Re: Shieldalloy Metallurgical Corporation Superfund Site
Newfield, NJ
In the Matter of CERCLA Docket No. 02-2010-2017
Response to Comment on, and Addendum to OU2 Pre Design Investigation
Results Report

ENCLOSURE
TRC's March 2016 Response to March 2, 2016 EPA Comments on, and
Addendum to the SMC OU2 PDI Results Report

JOB NUMBER: 112434
DD/TW DATE: MARCH 2016 FIGURE: 5

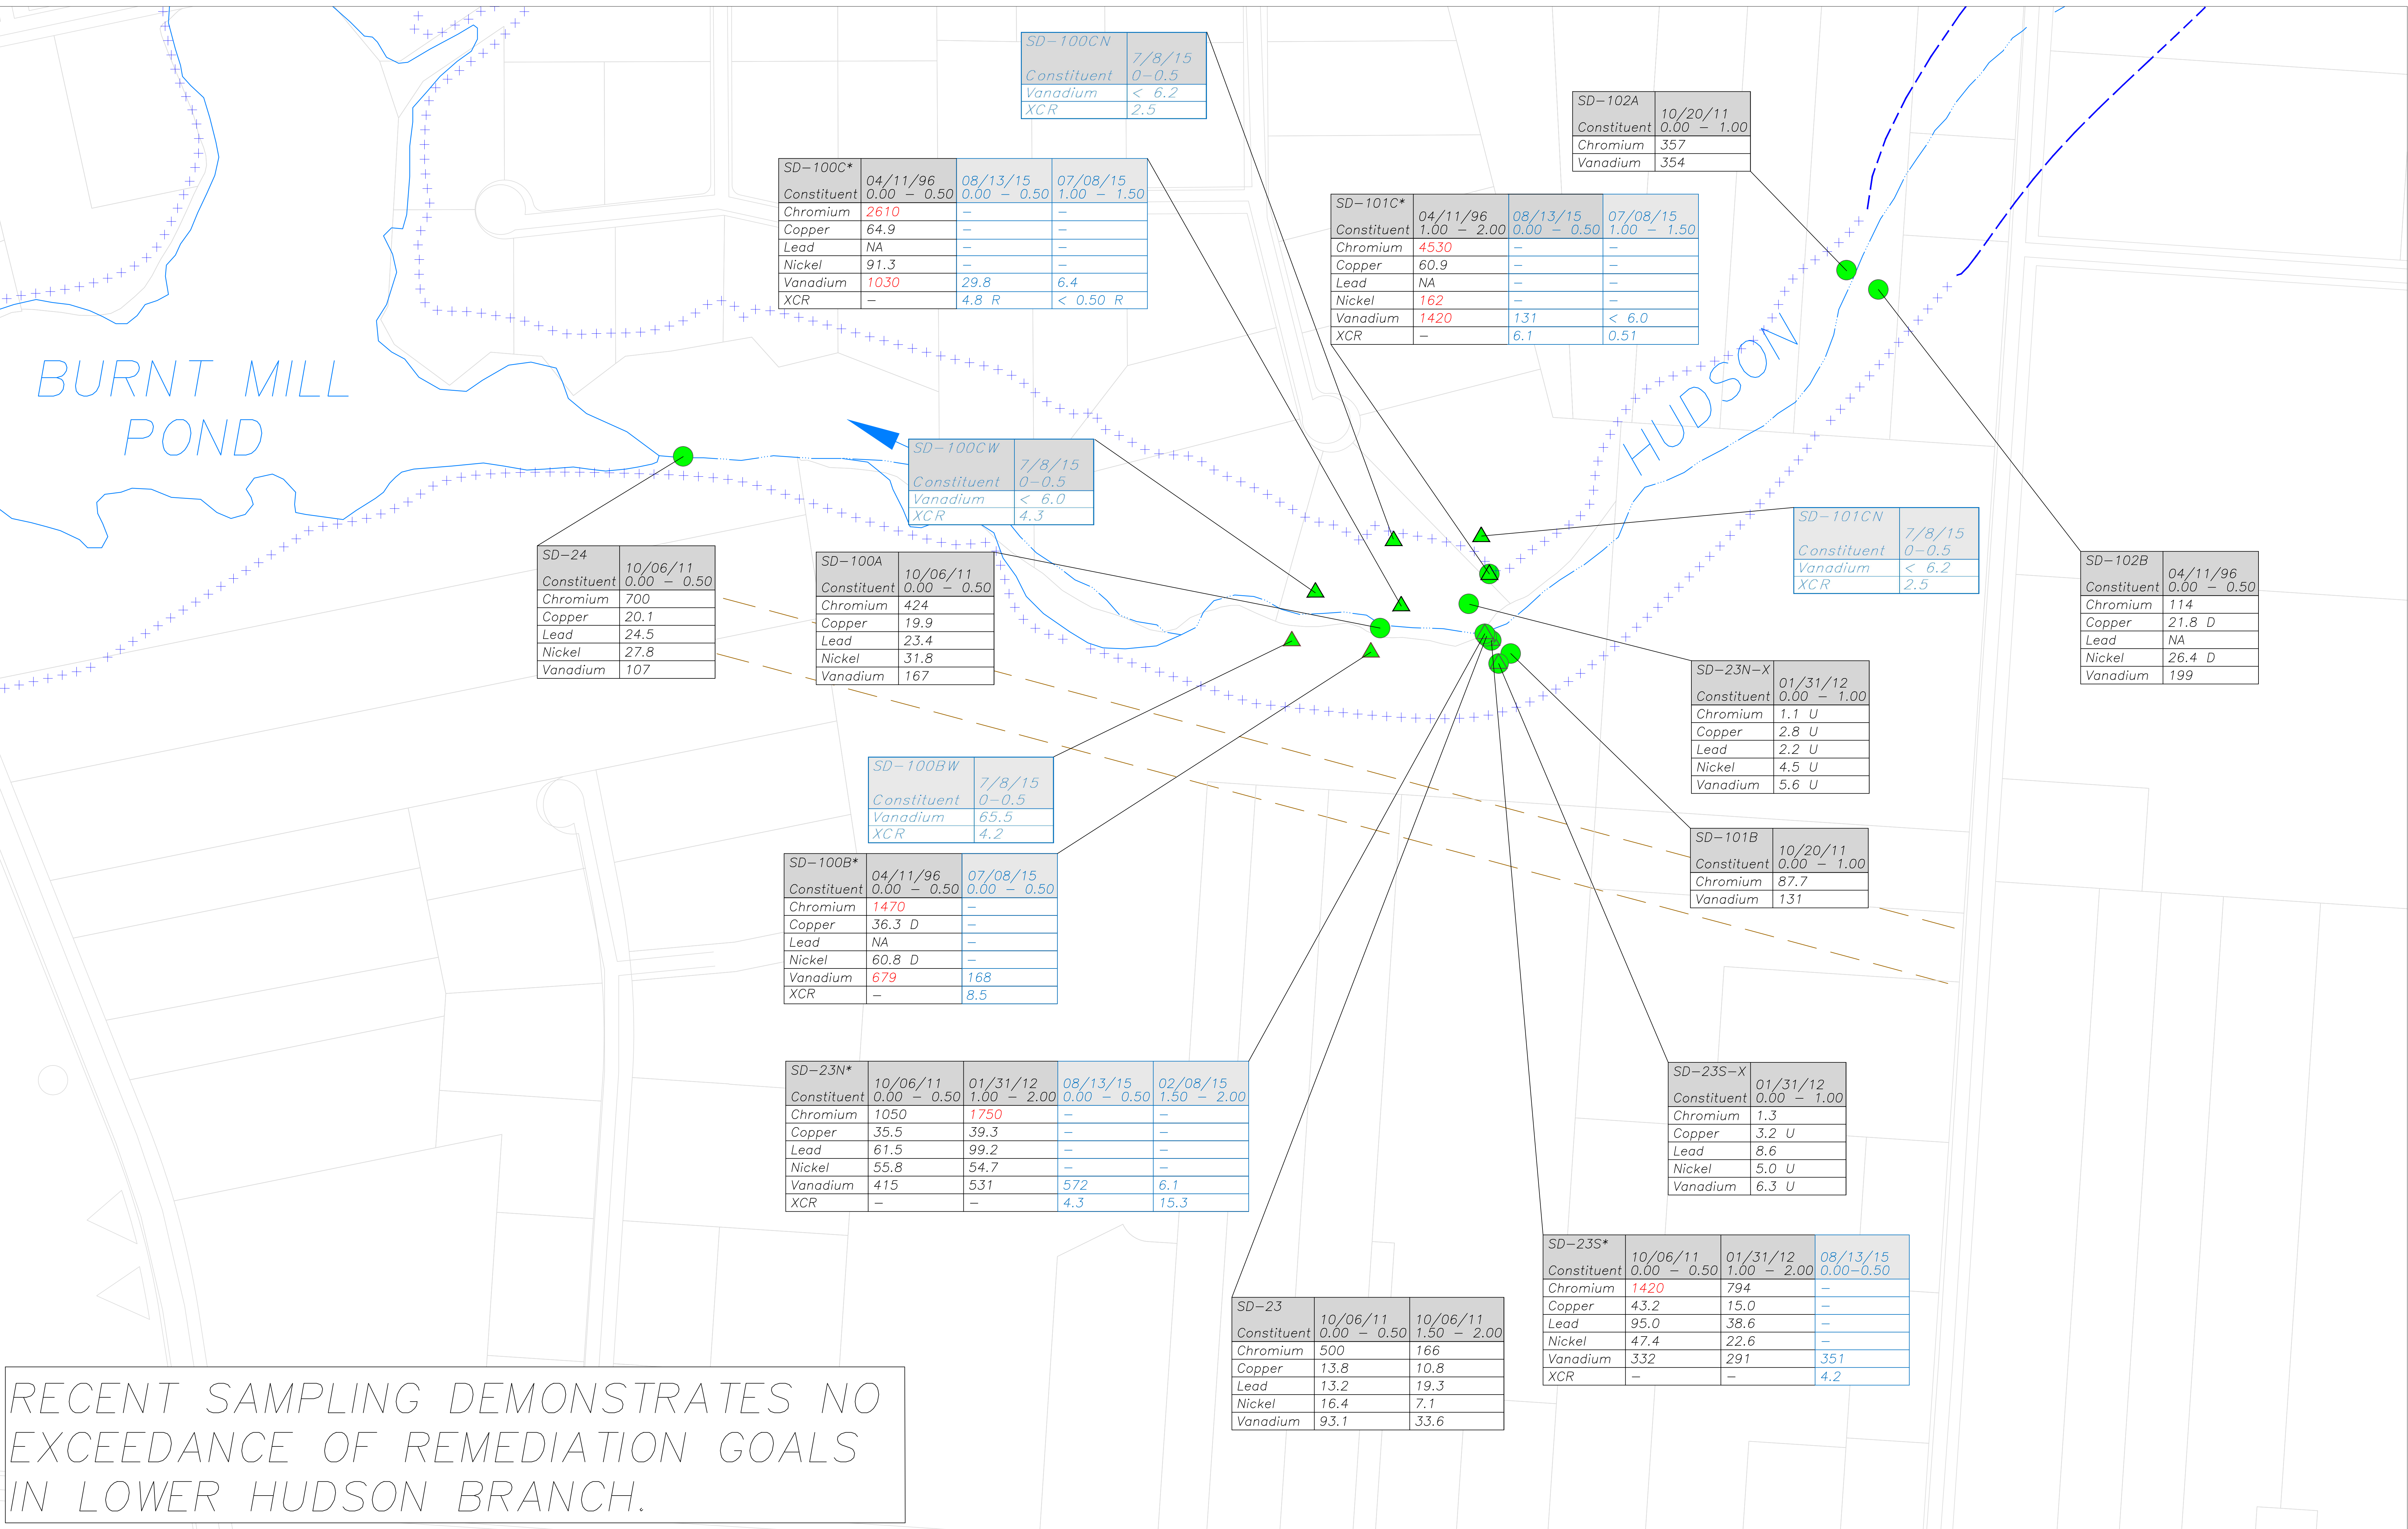
EPA Comment:

Three soil sample locations are shown as green triangles with no data boxes, and Table 6 includes results for four samples that are not shown on Figure 5. All data from Table 6 must be presented on Figure 5.

Adjusted Figure 5 is attached. Unintendedly, the data boxes and some data was left out during conversion to PDF and hard copy versions.
